# TOWN OF CHAPEL HILL

COMMUNITY DESIGN COMMISSION

January 22, 2019 - Minor Alteration Request

## HILLSTONE CHAPEL HILL

## PROPOSED SITE PLAN

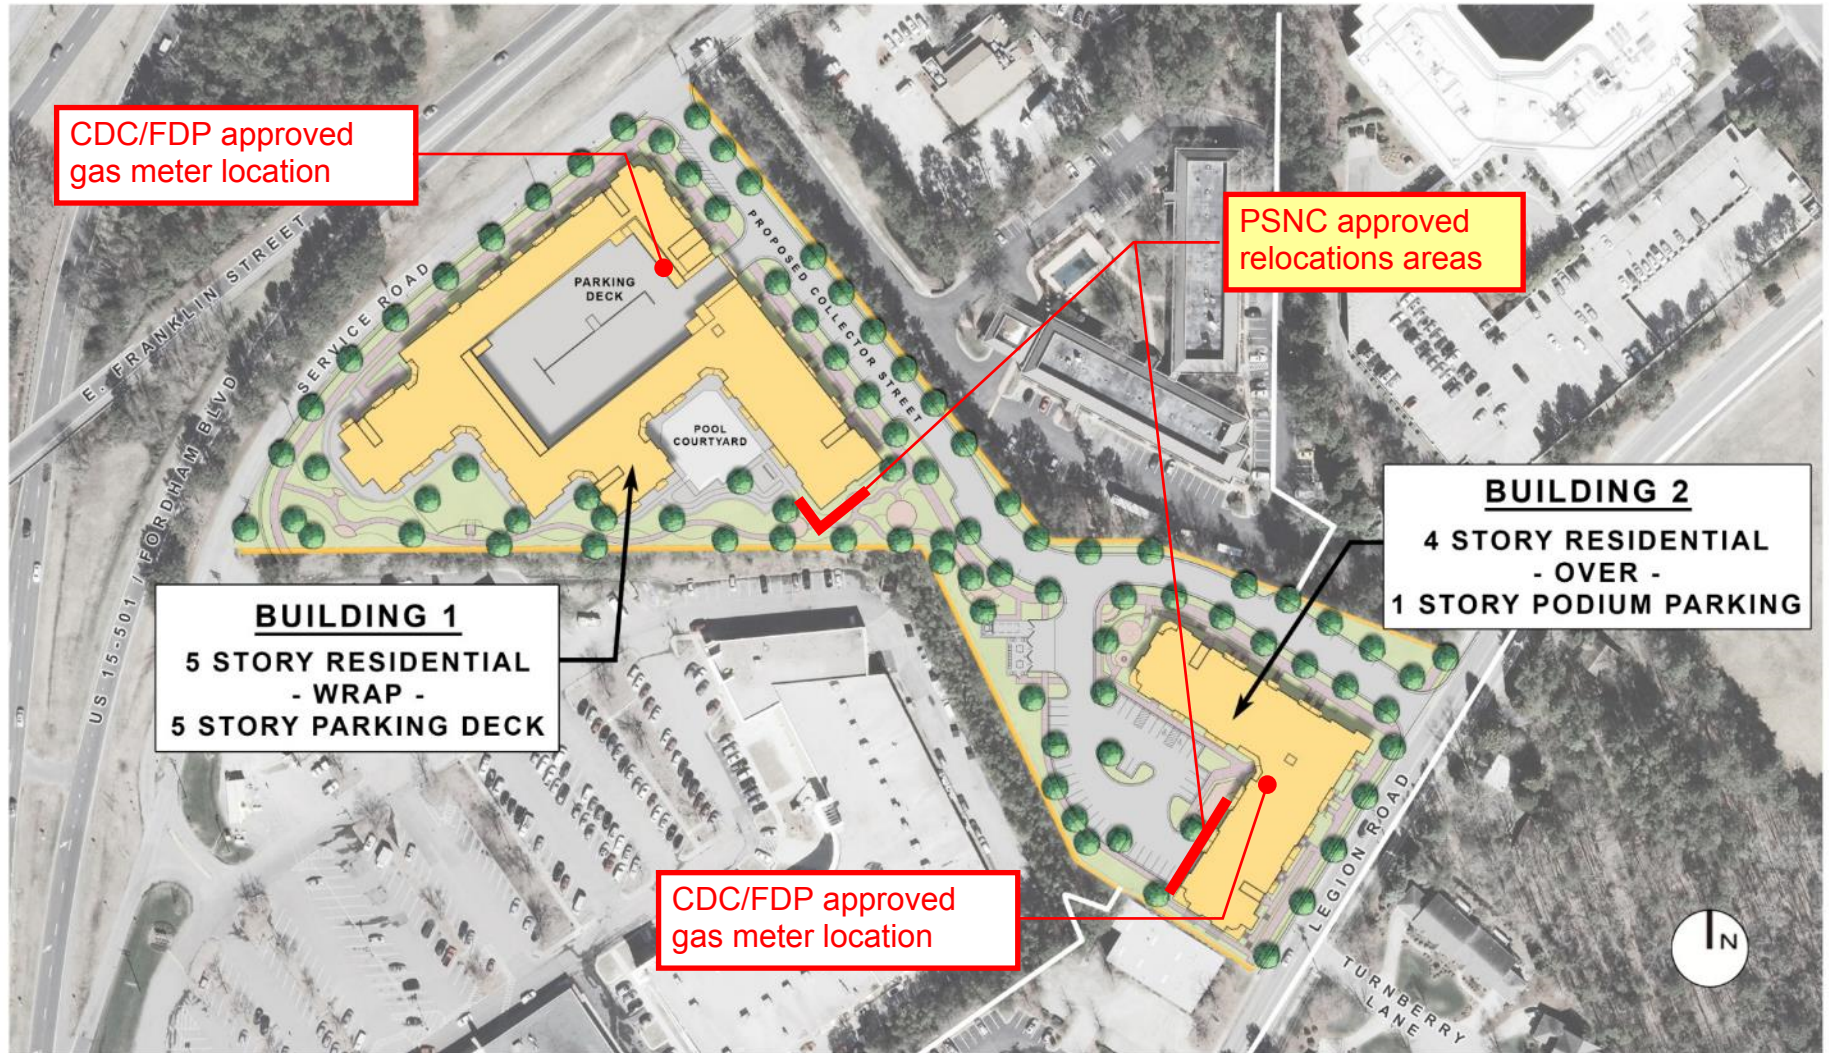
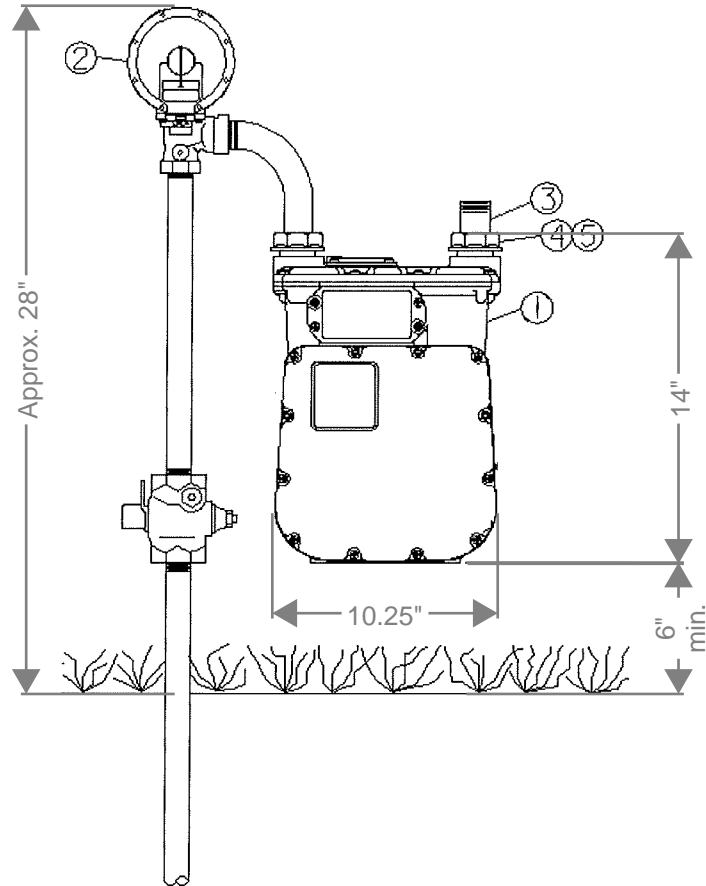
## 1. Relocation of Gas Meters onto Exterior Building Elevations

*PSNC originally approved the CDC & FDP approved locations for the gas meters within the building footprints. After construction began, PSNC rescinded this approval, stating they could not install or maintain meters within the building footprint.*

CDC/FDP approved gas meter location

Proposed relocation of gas meter for CDC review/approval

Locations on building elevations identified by PSNC as adequate for meter relocation

**Relocate meters to exterior building elevations accessible by PSNC and away from street views immediately adjacent to the site.**

## ELEVATIONS - BUILDING 1 AT POOL COURTYARD

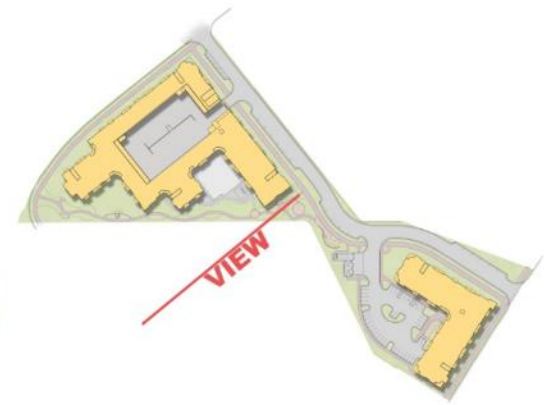
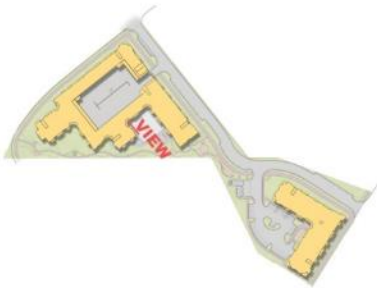
Locations on building elevation identified by PSNC as adequate for meter relocation

**EAST ELEVATION - BUILDING 1 FACING  
PEDESTRIAN CONNECTOR**

Locations on building elevation identified by PSNC as adequate for meter location

Proposed relocation of gas meter for CDC review/approval

## PROPOSED SITE PLAN

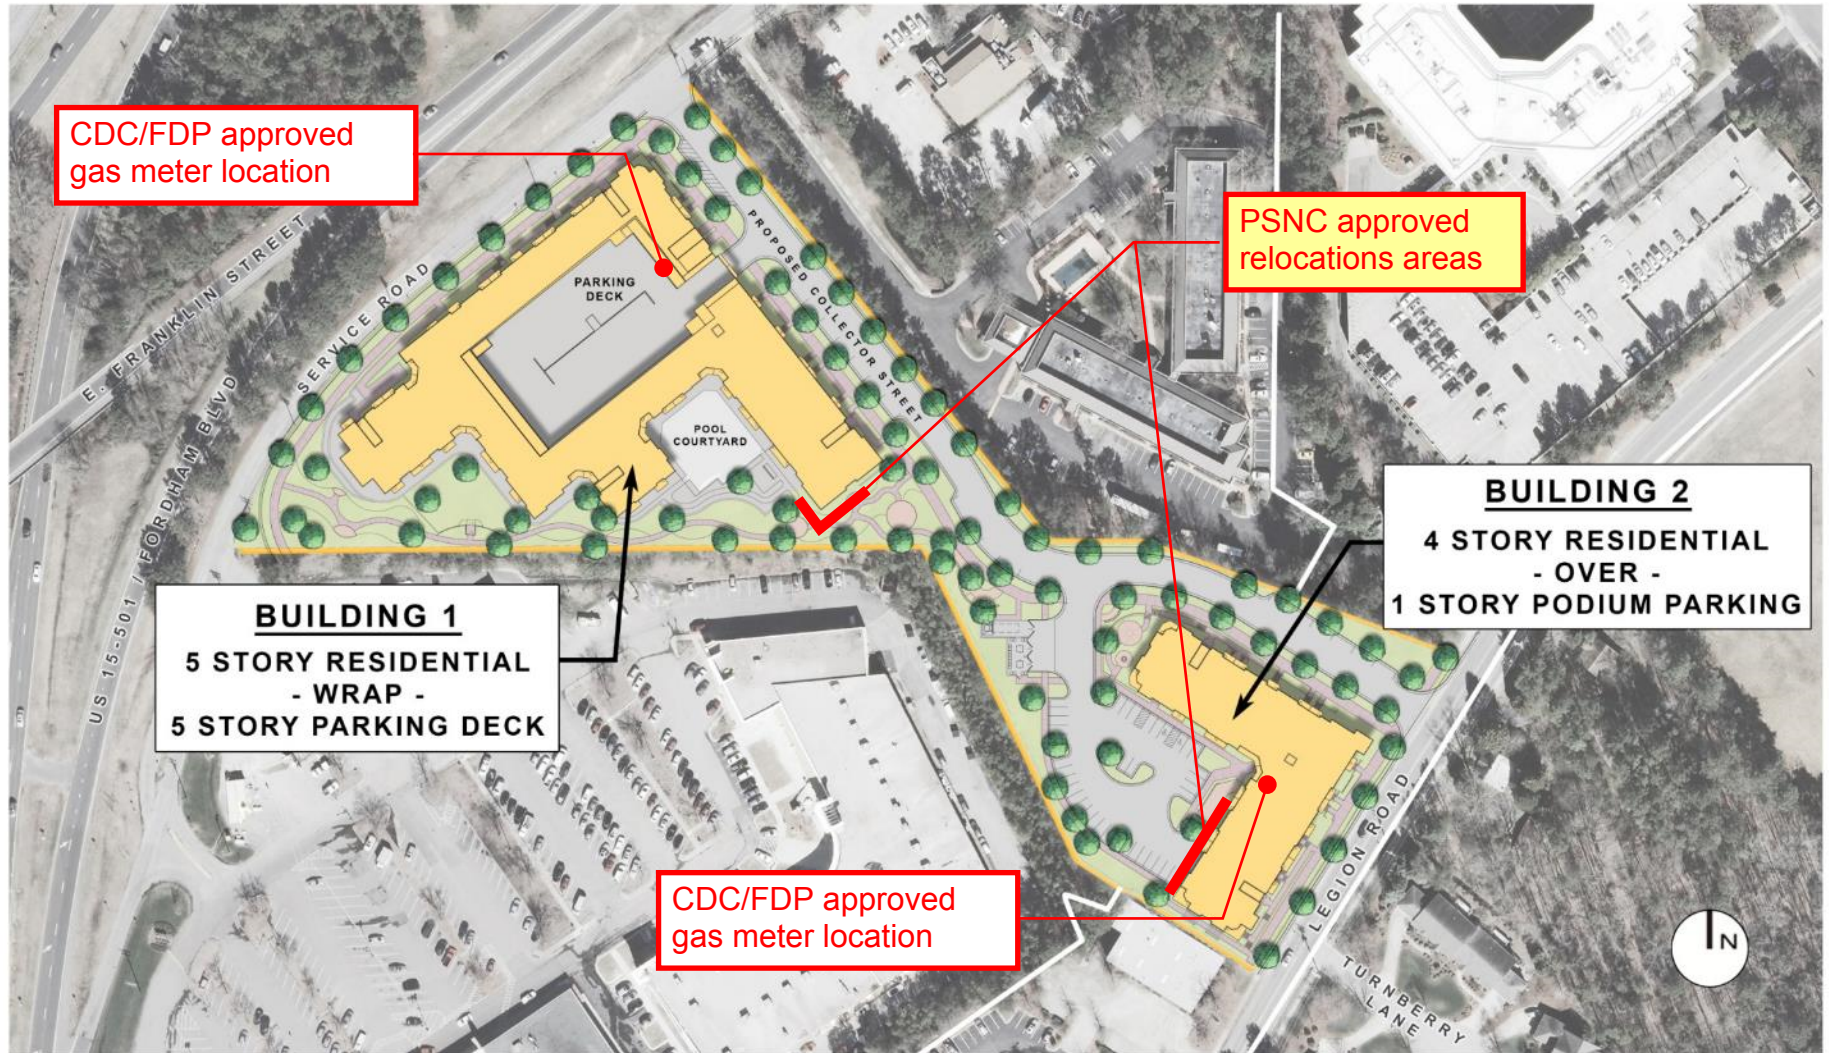
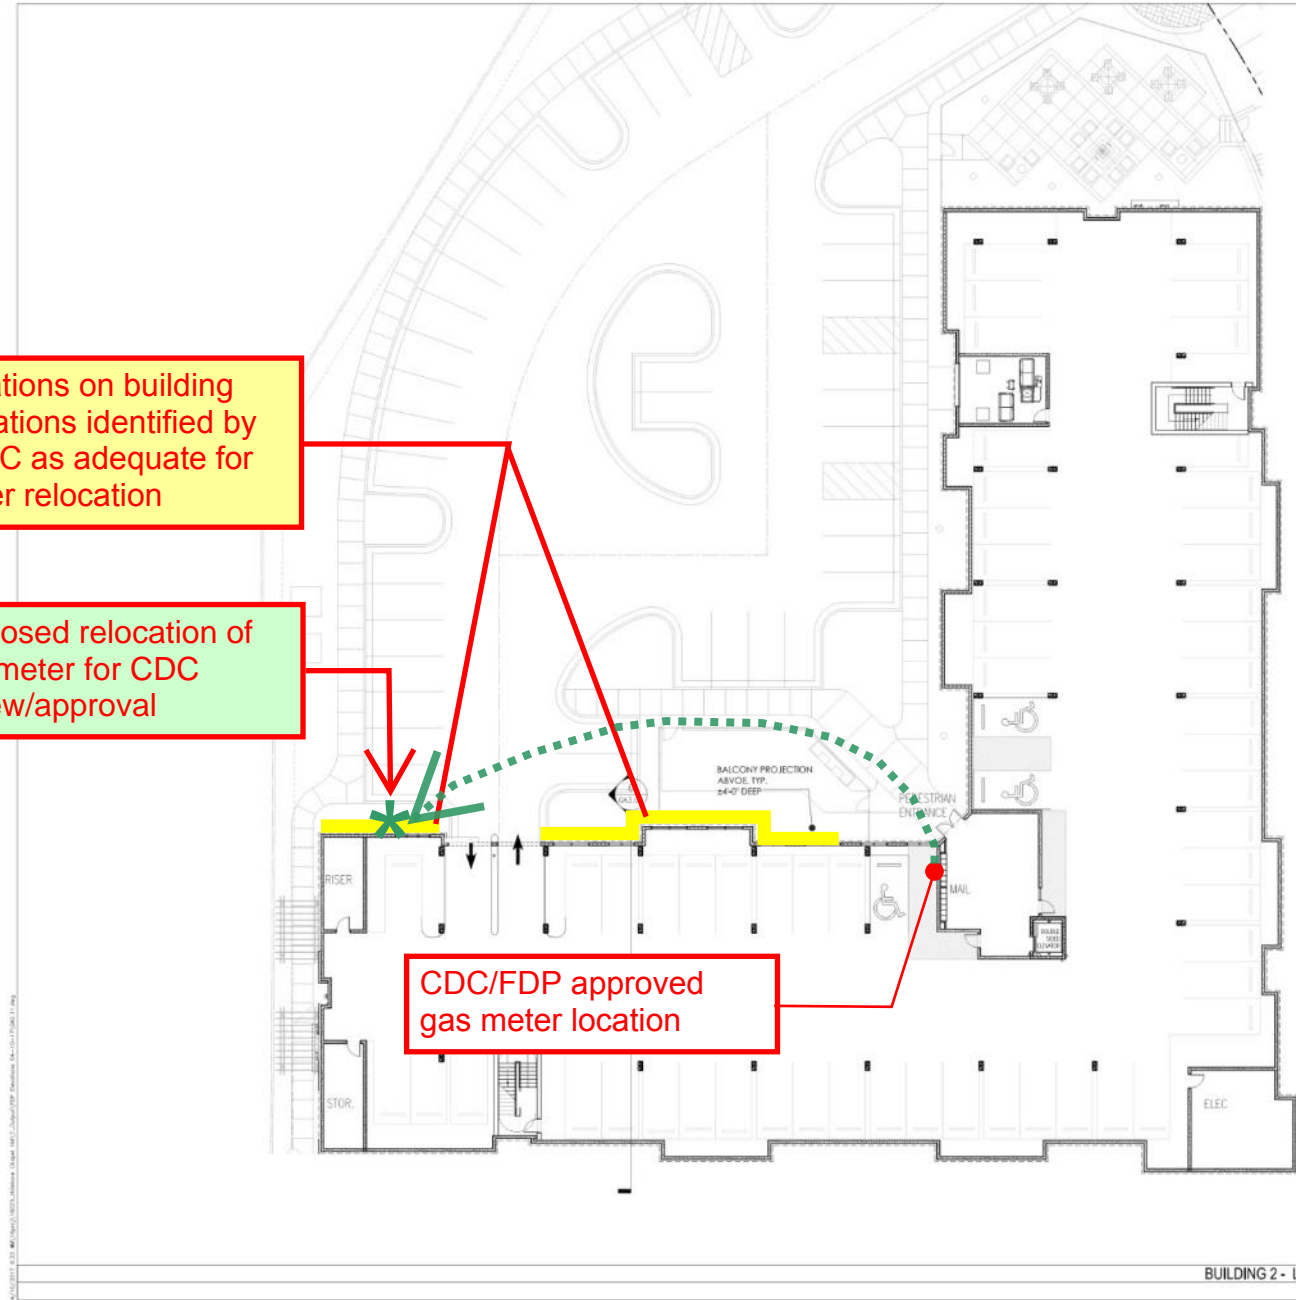
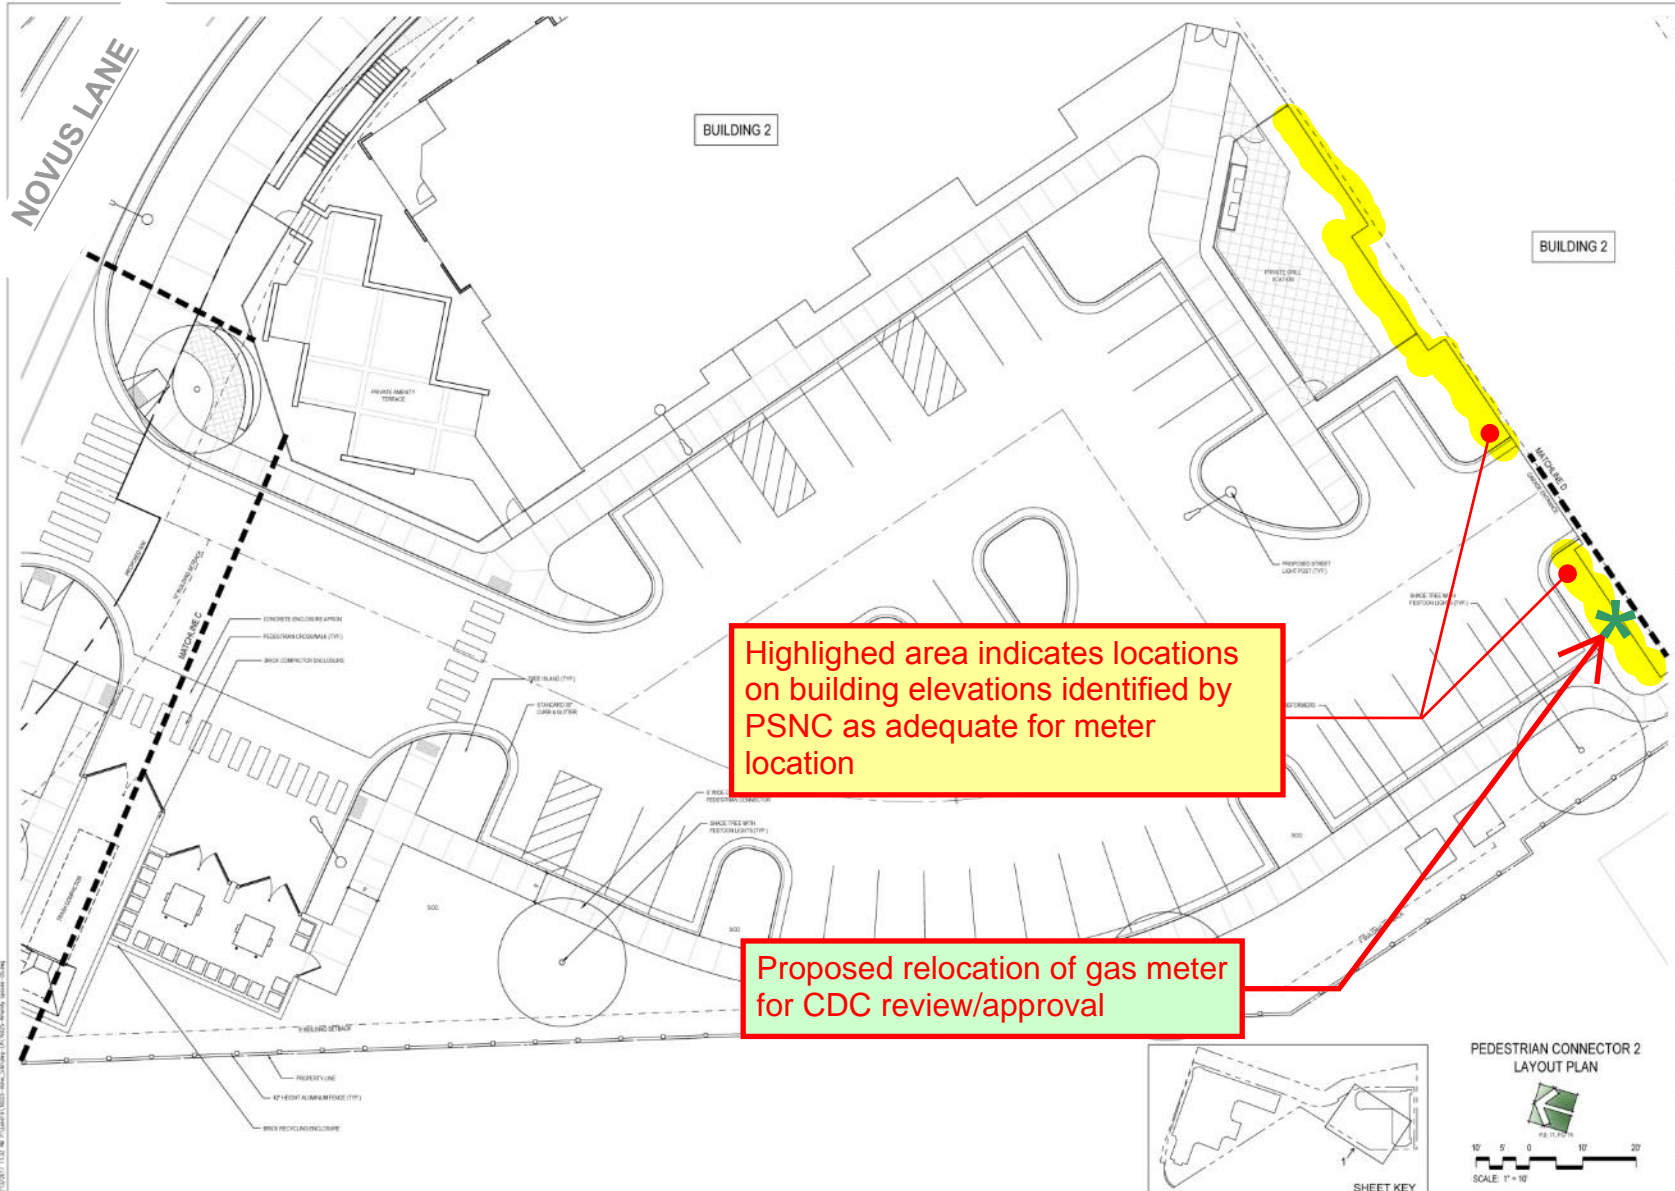
Locations on building elevations identified by PSNC as adequate for meter relocation

Proposed relocation of gas meter for CDC review/approval

CDC/FDP approved gas meter location
